marantz® SERVICE BULLETIN		Date: 10-Dec-2004	Model: DV9500
		Page: 1 / 4	REF.NBR: MZ04-081
Level		Application:	
★ ★ ★		See below	
		Subject: No power or does not operate after display with "MARANTZ"	
		Int.ref:

1-(2) Add a wire.

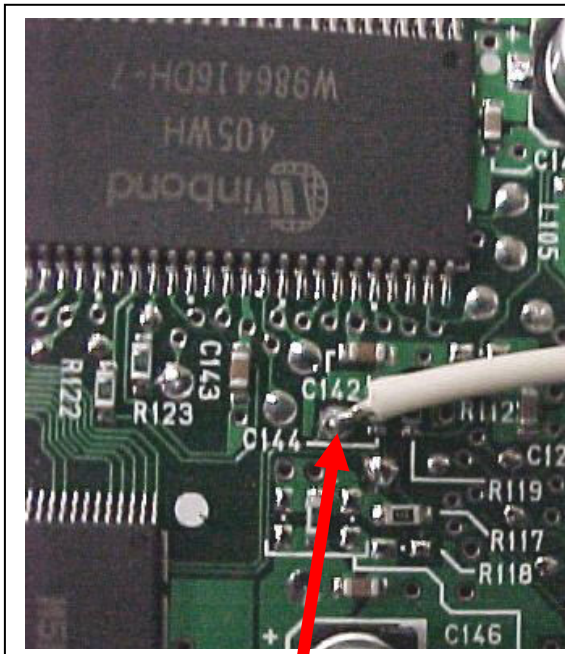
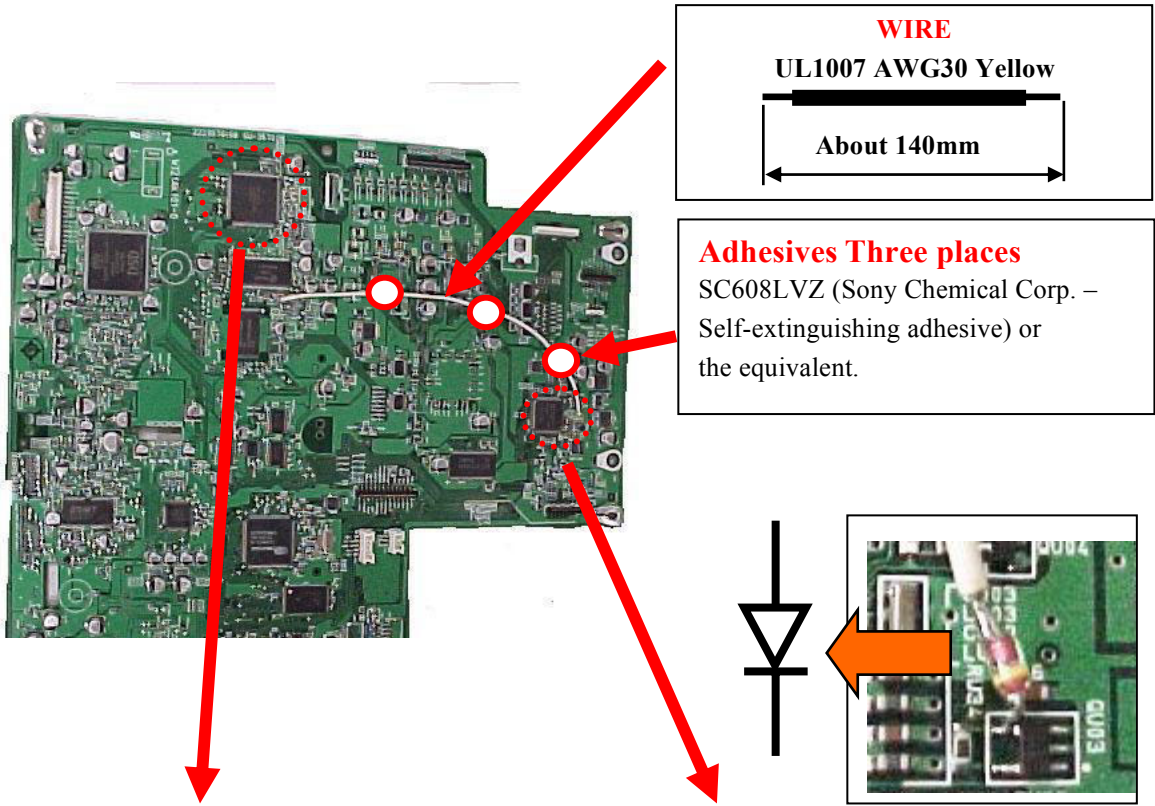
Connect a wire to this Test point (No.12 pin of Q103)

1-(3) Add a Schottky-DIODE (part no.: 00MHD20008020)

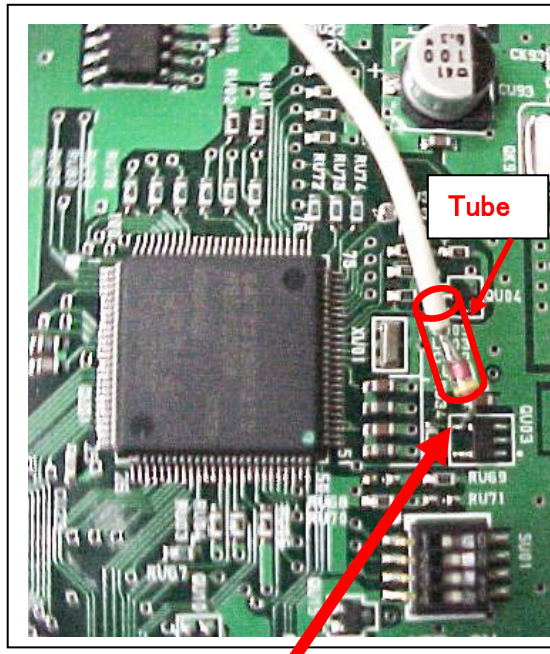
1. Add Schottky-DIODE and Insulation Tube.
2. Connect a wire to No.4 pin of QU03
